September 17, 1999

SUBJECT: PROPOSED RESOLUTION OF GENERIC SAFETY ISSUE-145, "ACTIONS TO REDUCE COMMON CAUSE FAILURES"

Yearly occurrence rate for complete CCF events, with 90 percent confidence band on the fitted trend.

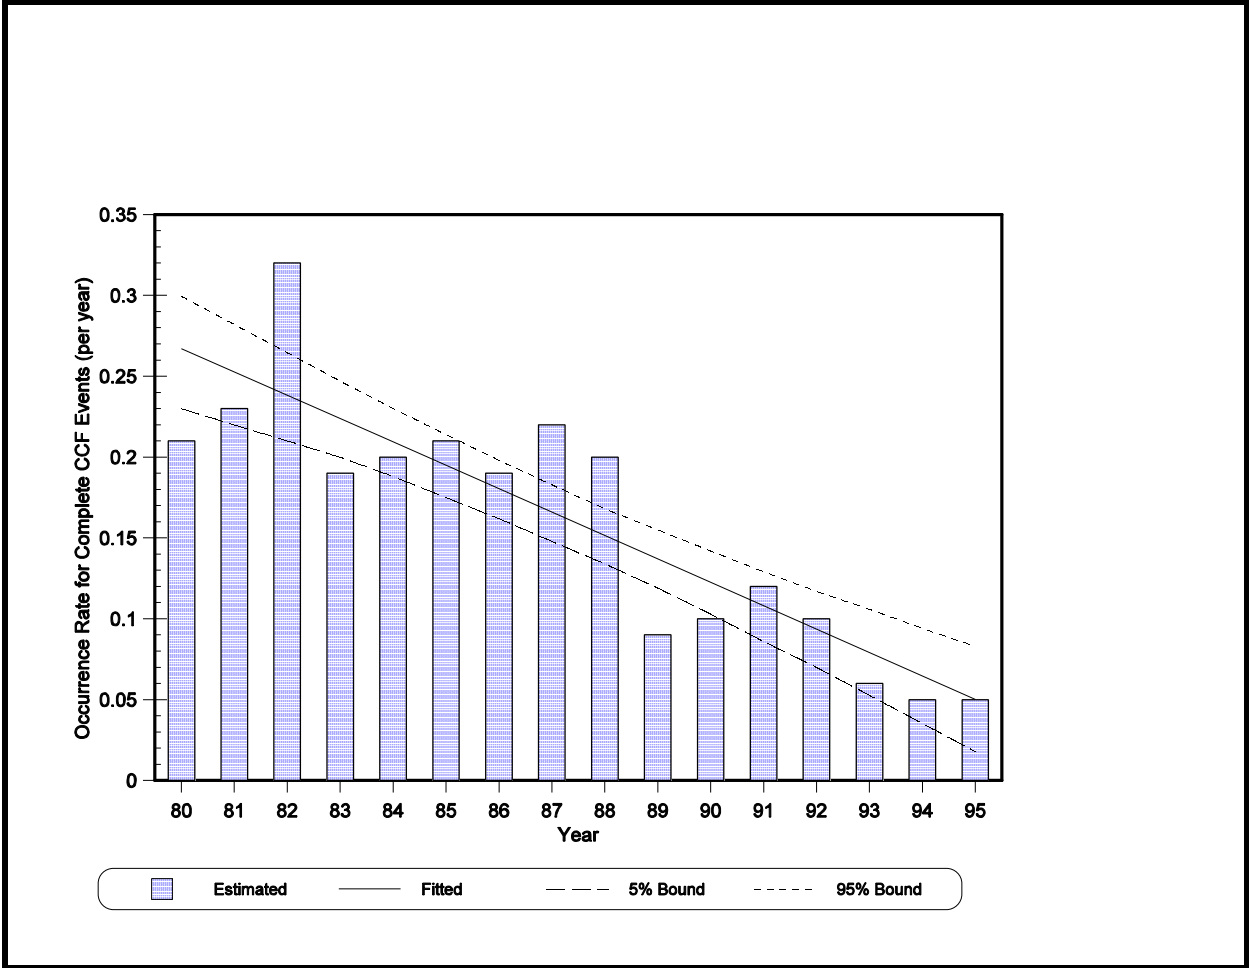
The efforts over the last 25 years to understand CCFs have been successful. The rate of occurrence of complete CCFs has been steadily decreasing (see attached Figure). Both the industry and the NRC staff have been sensitized to the significance of CCFs. A major contributor to this success has been the work sponsored by the former Office for Analysis and
